**REMEDIATION OVERSIGHT REPORT
FOR THE
D&G OPERATING CO., INC.
NO. 1 EVANS UNIT WELLSITE
NEAR WINNIE, TEXAS**

**OVERSIGHT REPORT
FOR THE EVANS UNIT WELLSITE**

**REMEDICATION OVERSIGHT REPORT
FOR THE
D&G OPERATING CO., INC.
NO. 1 EVANS UNIT WELLSITE
NEAR WINNIE, TEXAS**

Scan data inside the fence

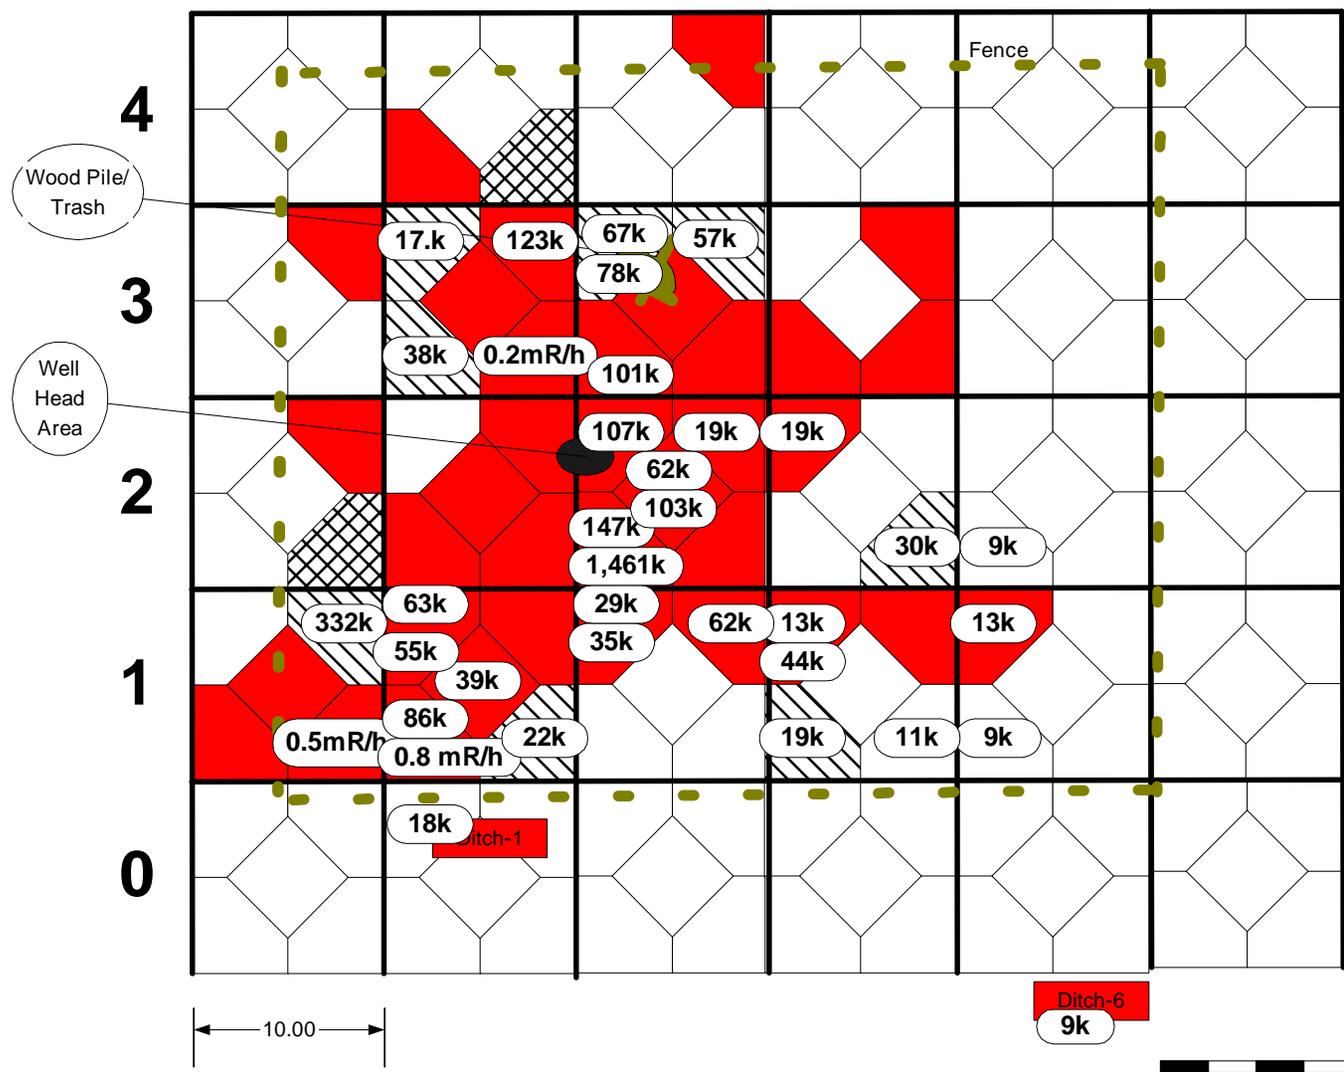
Scan data from inside the fence indicate that at least eight more subcells may be contaminated: B1-2, B2-1, C3-4, C3-5, D1-1, D3-2, D3-5, and E1-4. All of these subcells were logged as greater than 12k cpm while RFP soil sample results do not indicate > 6pCi/g. *These eight subcell areas need further characterization, both scanning and soil sampling, to confirm the contamination level.*

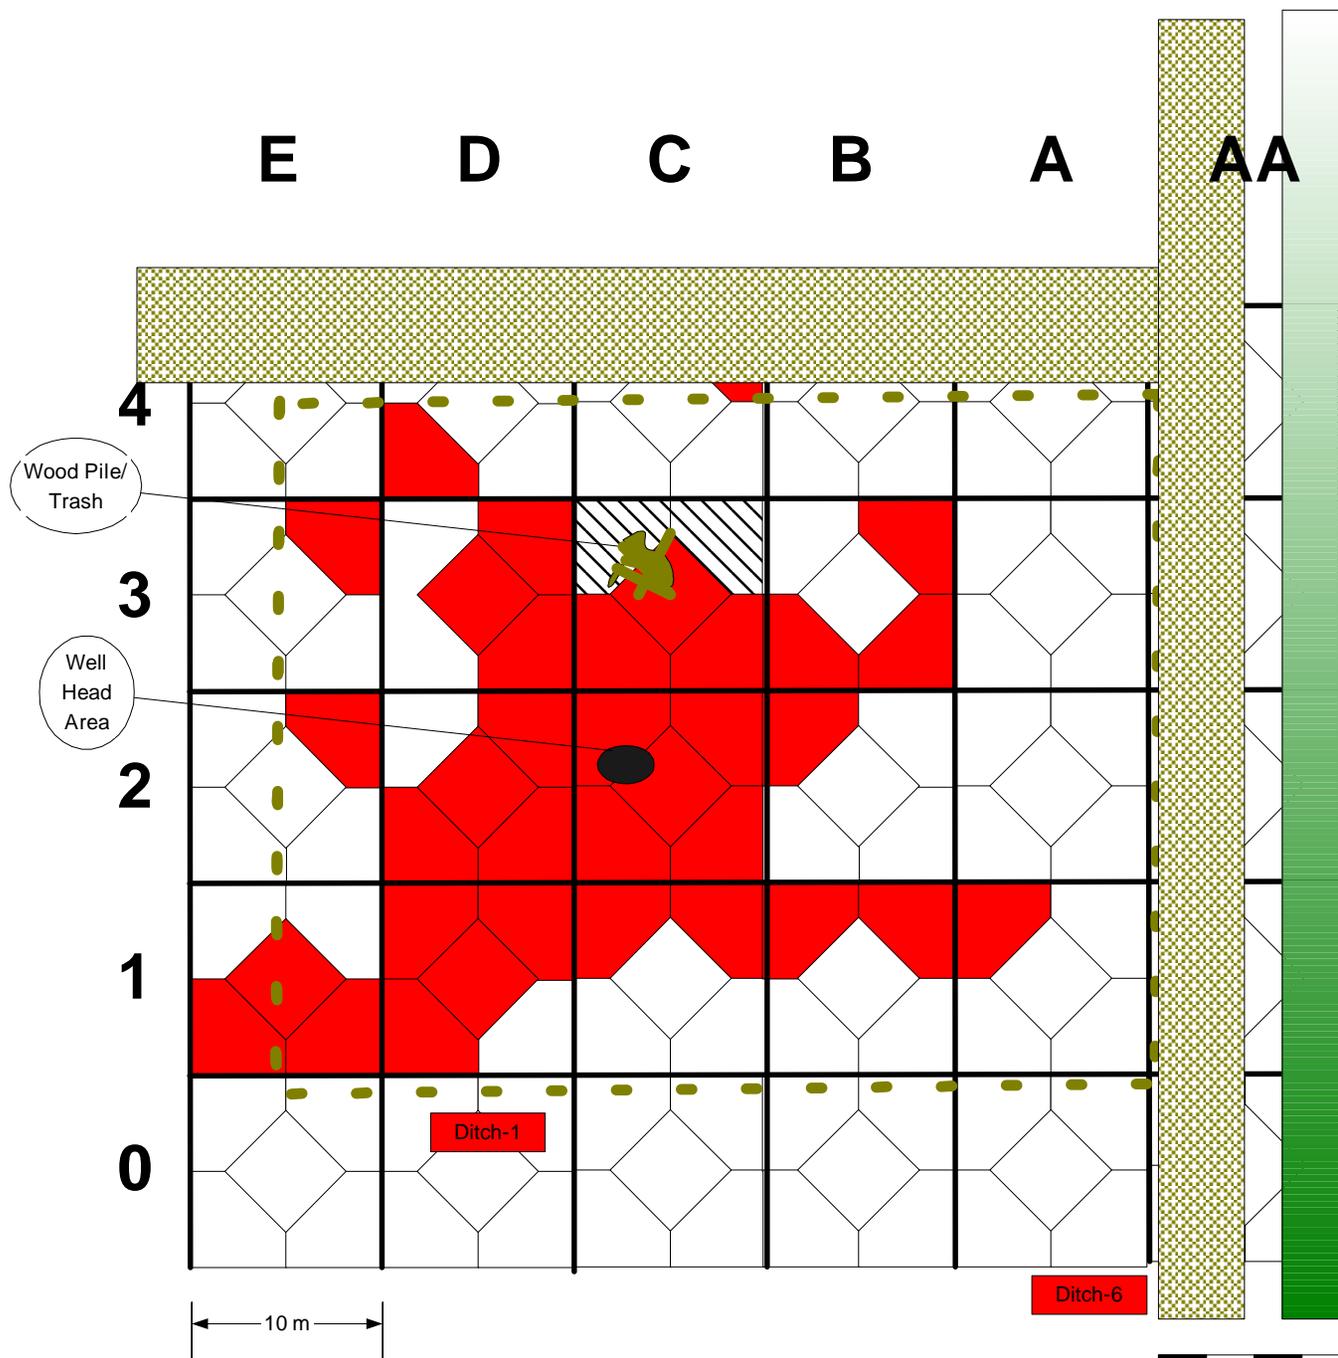
Future drawings of the area should reflect that there is no pond immediately inside the gate (NE corner of most drawings). Drawings should reflect that the N-S road has its western edge at the fence line; show that about half of the AA column is a ditch on the eastern side. Drawings should reflect that the E-W road.

The boundaries of contamination on the north and west sides of the fenced area should be the road sides adjacent to the fenced area.

Scanning data and soil sampling results of the roadways demonstrate that the contamination levels are below 6 pCi/g; additional scanning and sampling is not warranted.

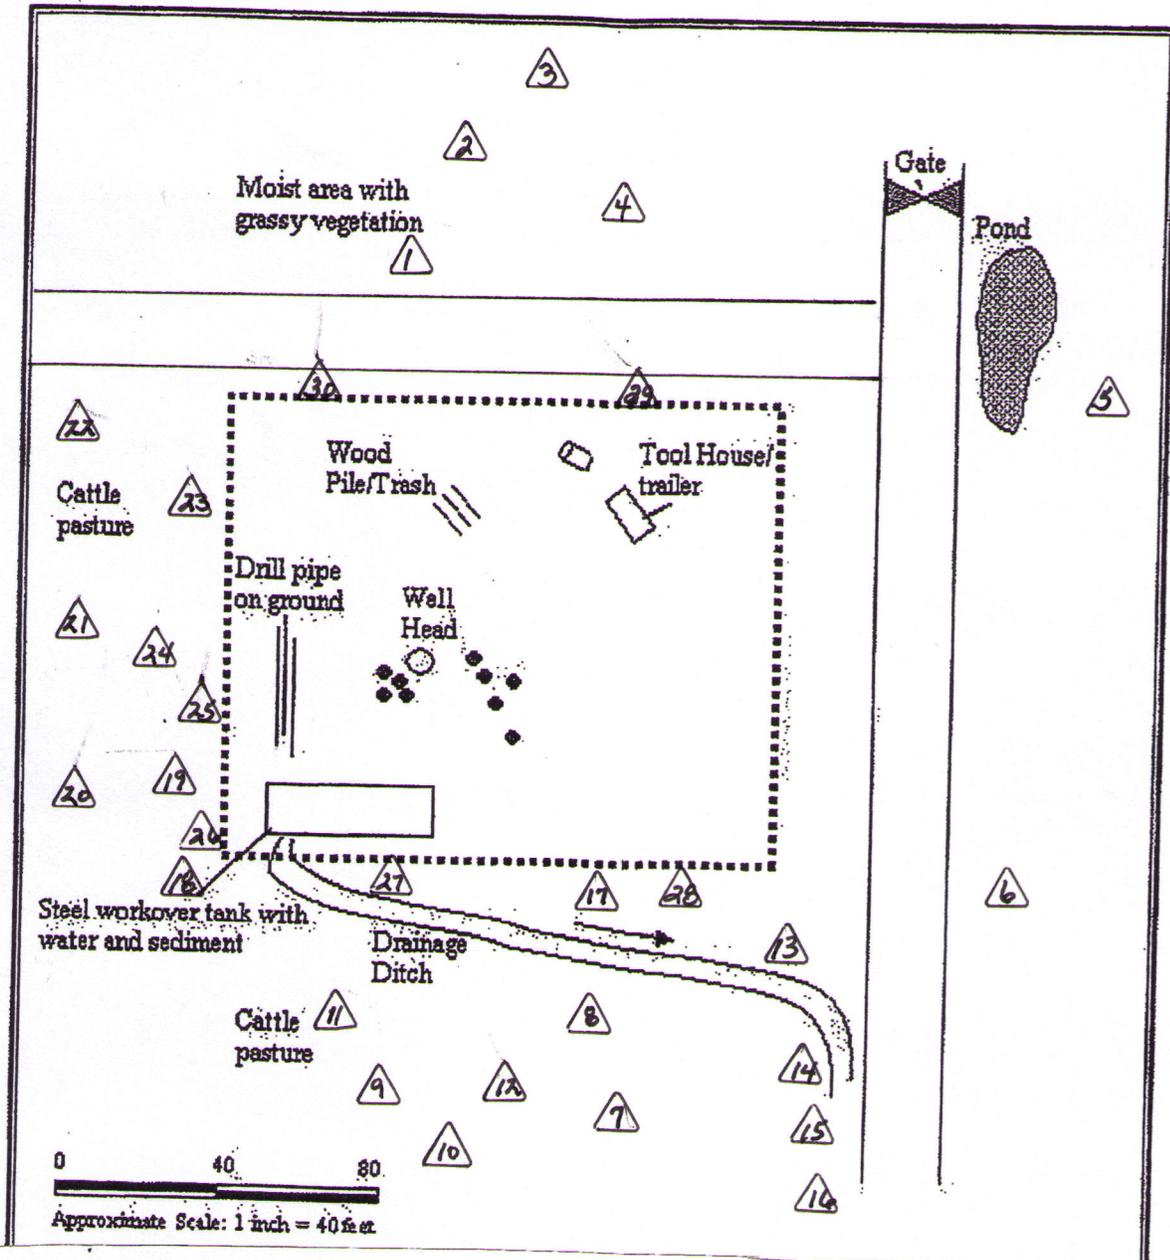
Drawing 2 indicates the soil samples collected before improvements and additional rock layers was placed on the road. Locations 2 through 7 would be located within the AA grid column and 9 through 11 would be located within the northern half of Row 4. The following table lists the sample results.

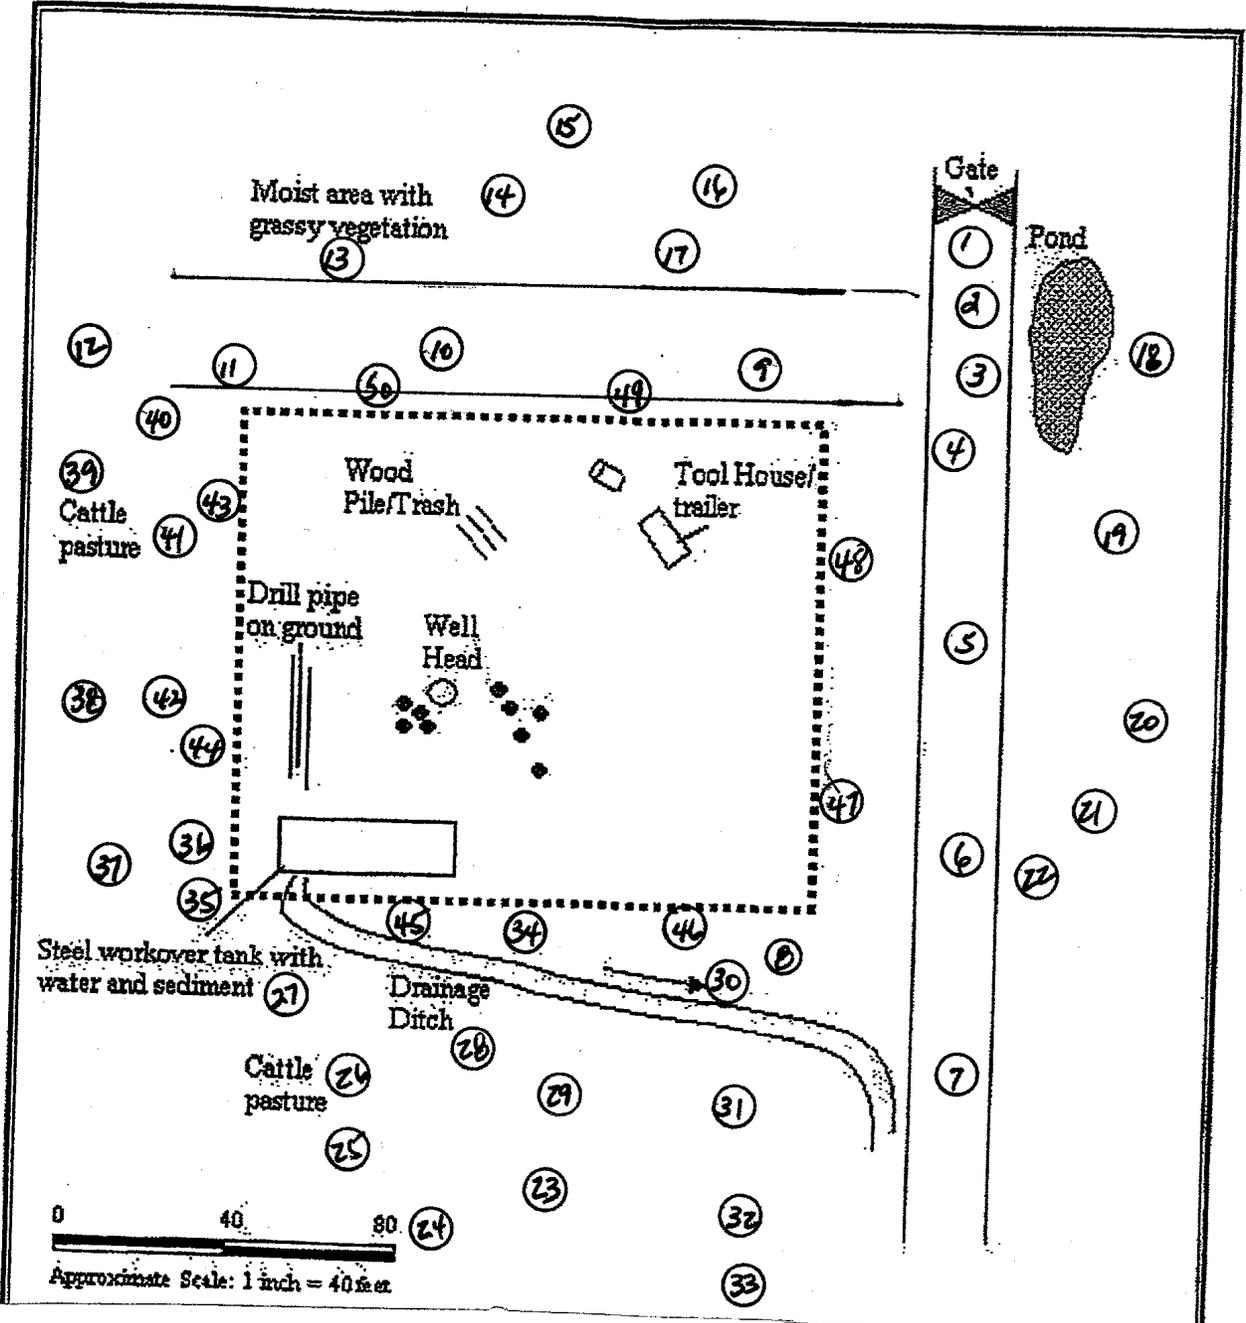
Drawing 3 indicates the random soil sample locations collected by ES outside the fenced area during the baseline survey. The sample locations 5 and 6 are in close proximity to the Grid areas AA and sample numbers 29 and 30 are outside the fence area but in Row 4. The following table lists these sample results.
